Crystal River Nuclear Plant
Docket No. 50-302
Operating License No. DPR-72

Subject: Crystal River Unit 3 – Response to Request for Additional Information on the Third 10-Year Inservice Inspection Interval Requests for Relief 09-001-II, 09-002-II and 09-003-II (TAC NO. ME0905, ME0906 and ME0907)

RESPONSE TO REQUEST FOR ADDITIONAL INFORMATION

Figure 1
Relief Nozzles

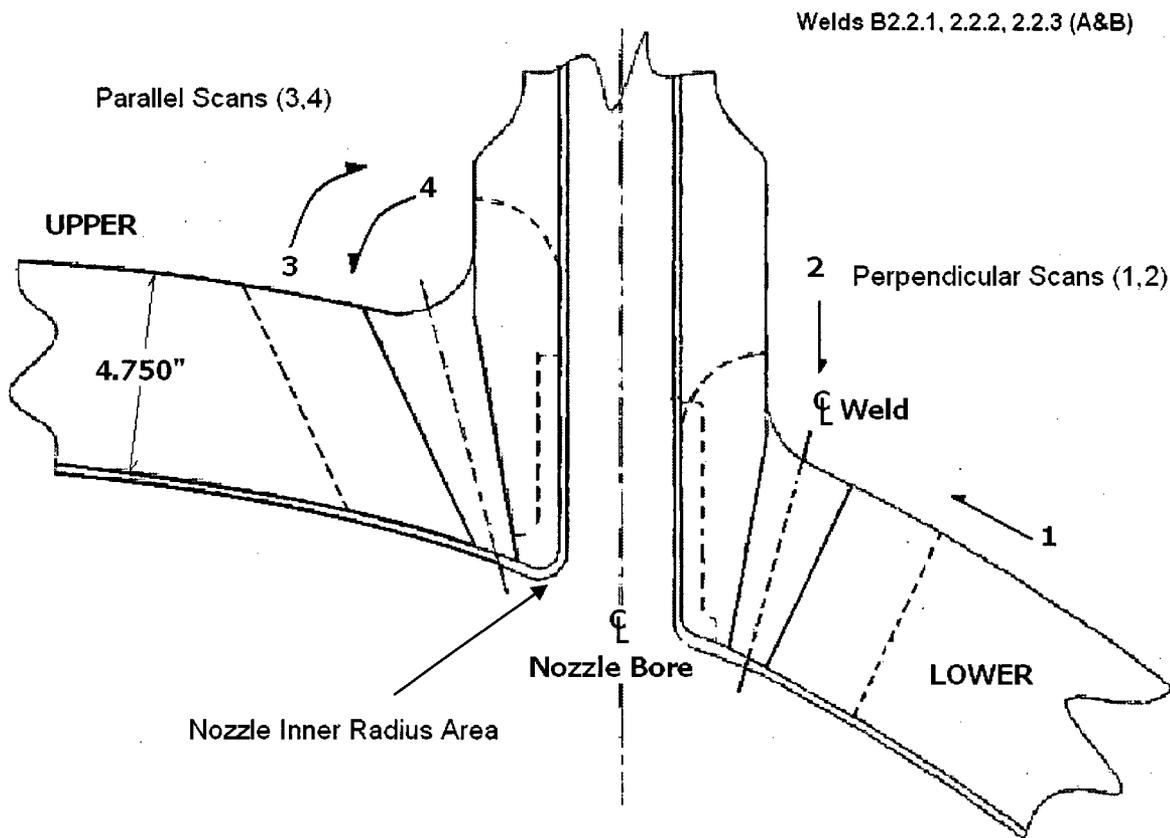
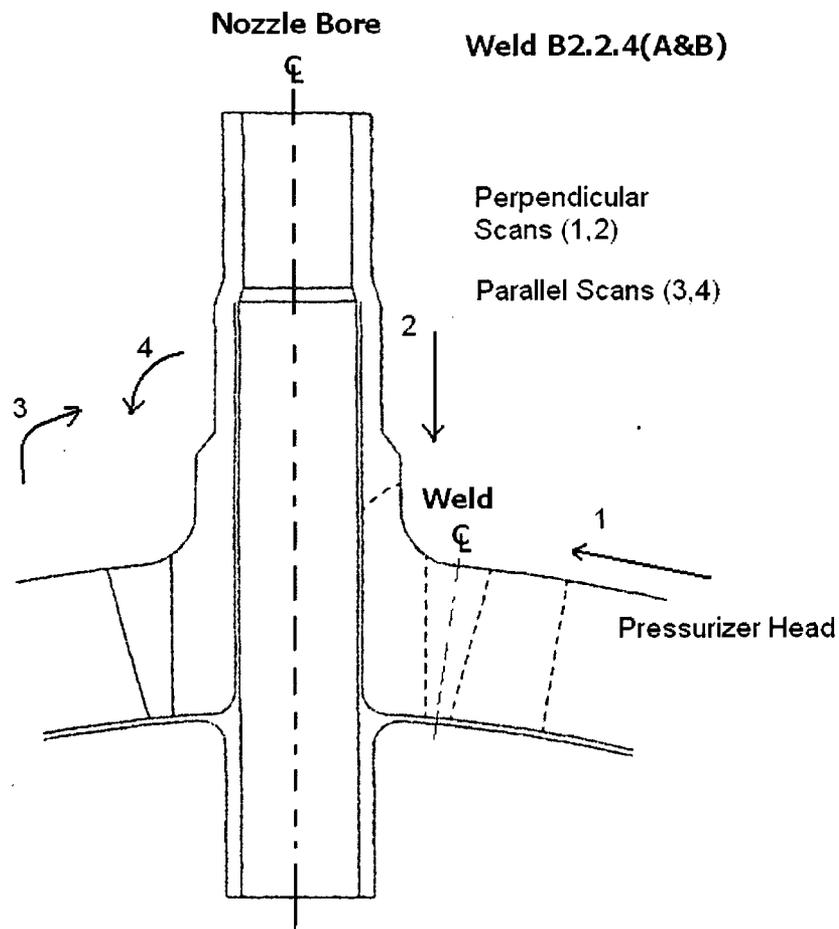
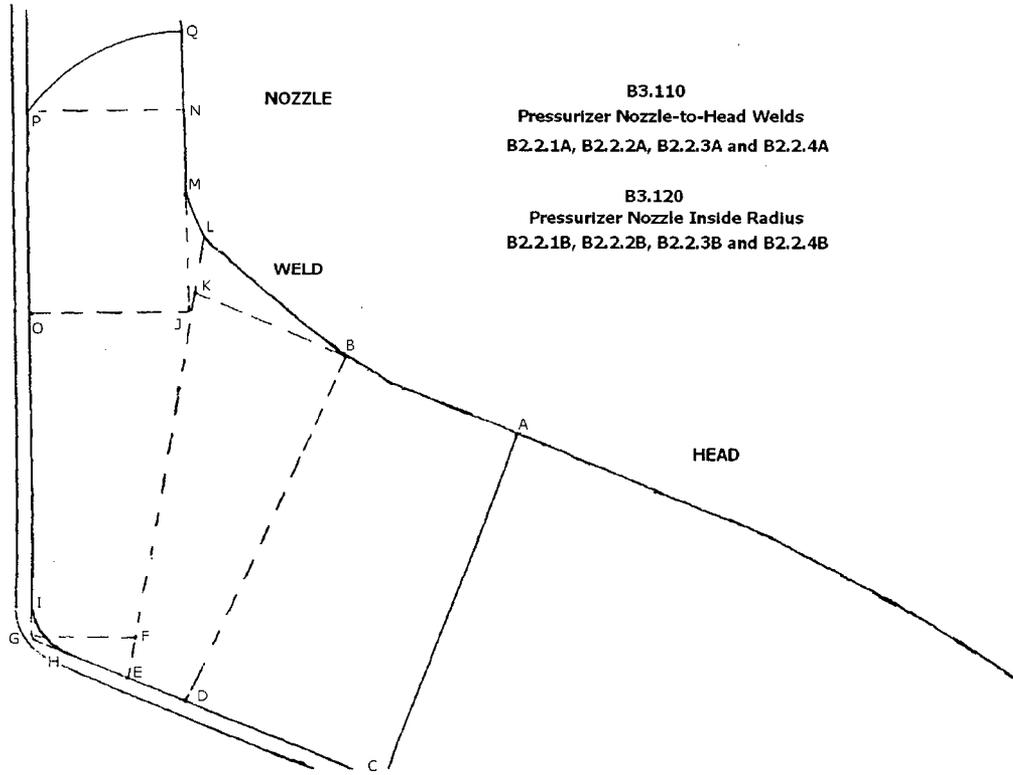
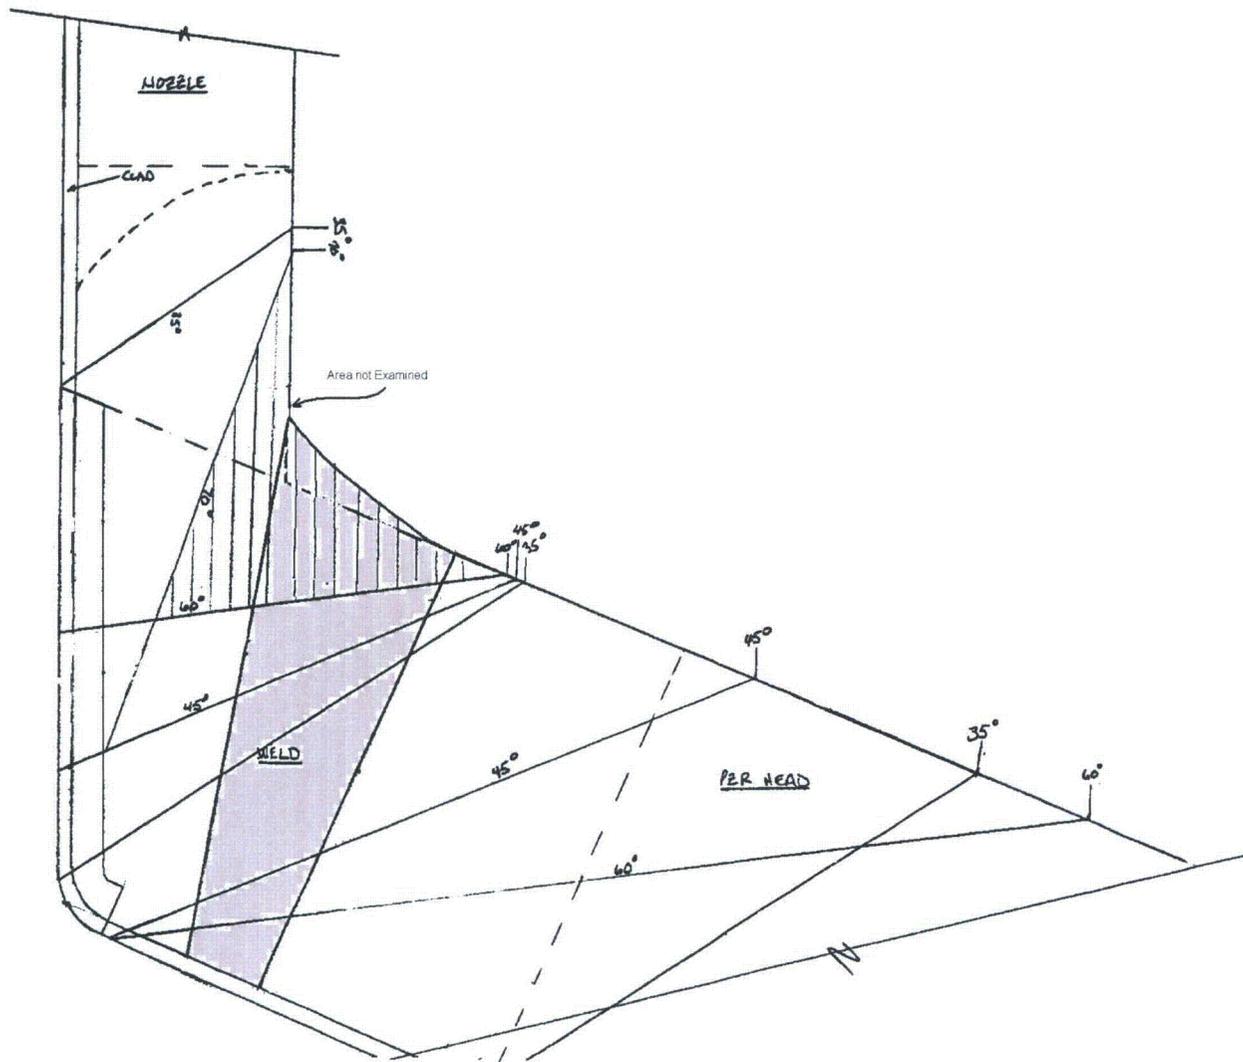
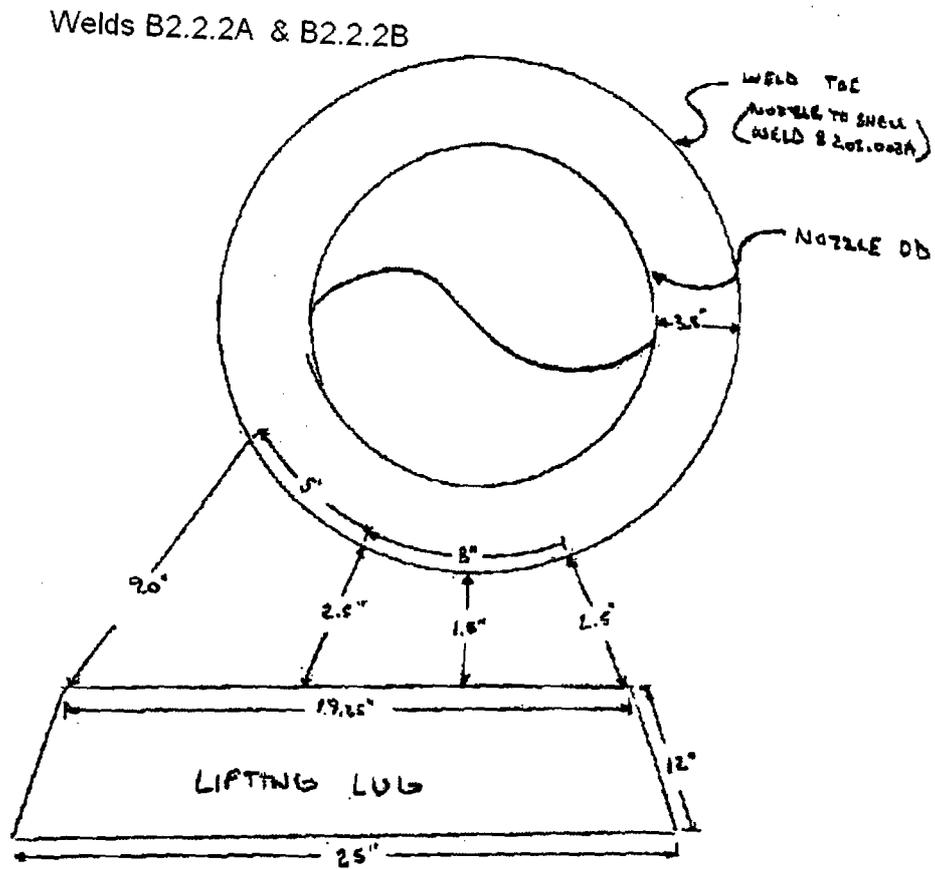
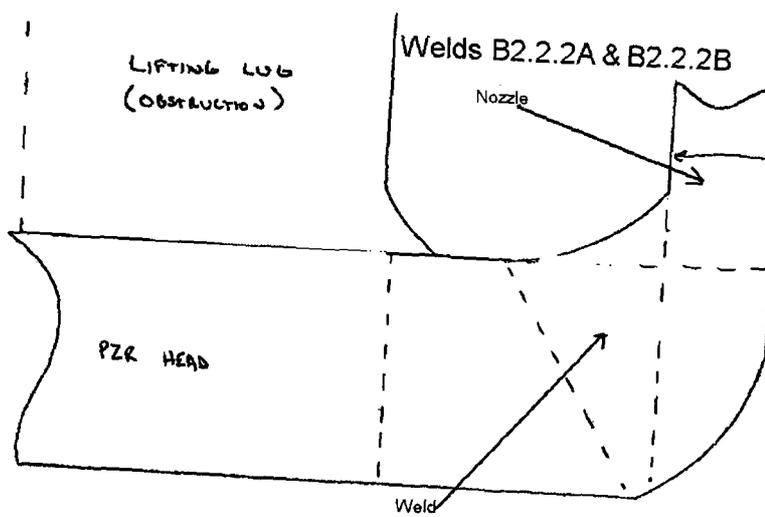
- 2.1.1 In Attachment A of Enclosure 1, the licensee has included multiple sketches and tables with volume coverage percentages for different angle beam orientations on steam generator and pressurizer nozzle-to-vessel welds and inner radius sections. However, in many of the sketches, it is unclear which portions, and how much of the ASME Code-Required Volumes have been completed. Please clearly describe or provide drawings showing volume coverage for each of the ultrasonic angles applied. Include dimensions, scanning directions and ultrasonic techniques (longitudinal or shear wave) used. In addition, list the base and weld materials. As applicable, describe NDE equipment (ultrasonic scanning apparatus), details of the listed obstructions (size, shape, proximity to the weld, etc.) to demonstrate accessibility limitations, and discuss whether alternative methods or advanced technologies could be employed to maximize ASME Code coverage.

During the manual ultrasonic examination of these nozzle-to-head welds and nozzle inner radii, less than 90% coverage of the required examination volume was obtained. The percentage of coverage reported for each weld represents the aggregate coverage from all scans performed on the weld and adjacent base material (pressurizer head). The examination coverage was based on the aggregate from each scan as follows:

The Crystal River Unit 3 (CR-3) Inservice Inspection Plan allows the use of Code Case N-460, which requires greater than 90% volumetric coverage of examination volume A-B-C-D-E-F-G-H-J (Figure 3). Therefore, the available coverage will not meet the acceptance criteria of this Code Case. The area not examined for the pressurizer nozzle-to-head welds are shown in Figure 4.

The pressurizer nozzle-to-vessel head welds and the pressurizer nozzle inner radii are accessible only from the head side, based on the nozzle curvature. The scanning surface of the nozzle is perpendicular to the head surface, which prohibits the ultrasonic wave entering the Code required examination volume at an angle that will integrate the weld volume for in-service flaws. In order to scan all of the required volume for this weld, the relief nozzles would have to be redesigned to allow scanning from both sides of the weld, which is impractical.

Welds B2.2.2A and B2.2.2B have an obstruction in the examination area from a welded lifting lug (Figures 5 and 6). The exam was limited for 13 inches radially for a limitation of 25% of the Code Required Volume. Combined with the total examination limitations, due to geometry and physical restriction, the total examination of Code Required Volume was approximately 50% and 42%, respectively.

Figure 11

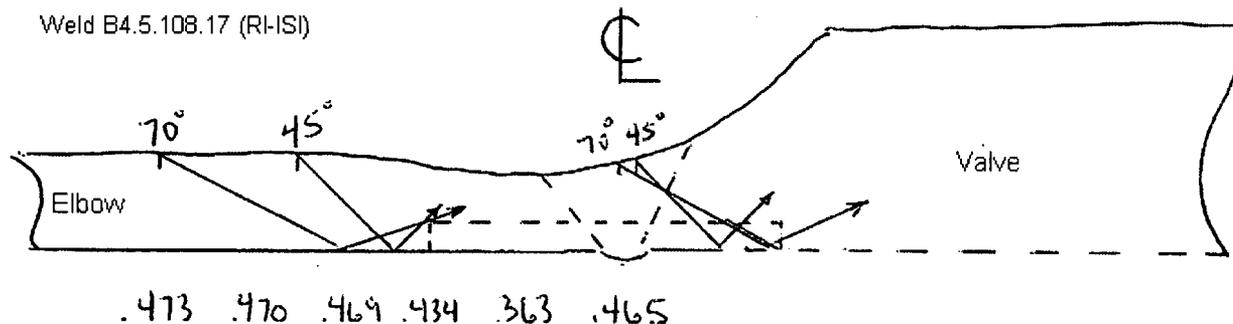
- 2.2.1 Provide further information to support the basis for each limited Examination Category B-J and R-A weld, and therefore, demonstrate impracticality. This information should include detailed descriptions with sufficient explanation for the clarification. It may refer to the enclosed lay-out or cross-sectional drawings/sketches to enable the staff to fully understand the causes of ultrasonic scan limitations and their impact on examination volume coverage.

The ultrasonic examination of the above pipe weld was limited in coverage due to component configuration, elbow-to-valve (Figure 11). It is not possible to perform the ultrasonic examination from both sides of the weld since the valve prohibits scanning from the down-stream side of the weld based on the scanning surface angle of the component. Additionally, the intrados of the elbow restricts scanning from approximately 1.5 inches through 4.5 inches circumferentially; therefore, the welds only received a single sided examination resulting in less than 90% coverage of the required examination volume, with an actual 50% coverage for the subject weld. The examination coverage was based on the aggregate from manual scans of the pipe side: 45° and 70° shear wave scans perpendicular and parallel to the weld in one axial direction and two circumferential directions.
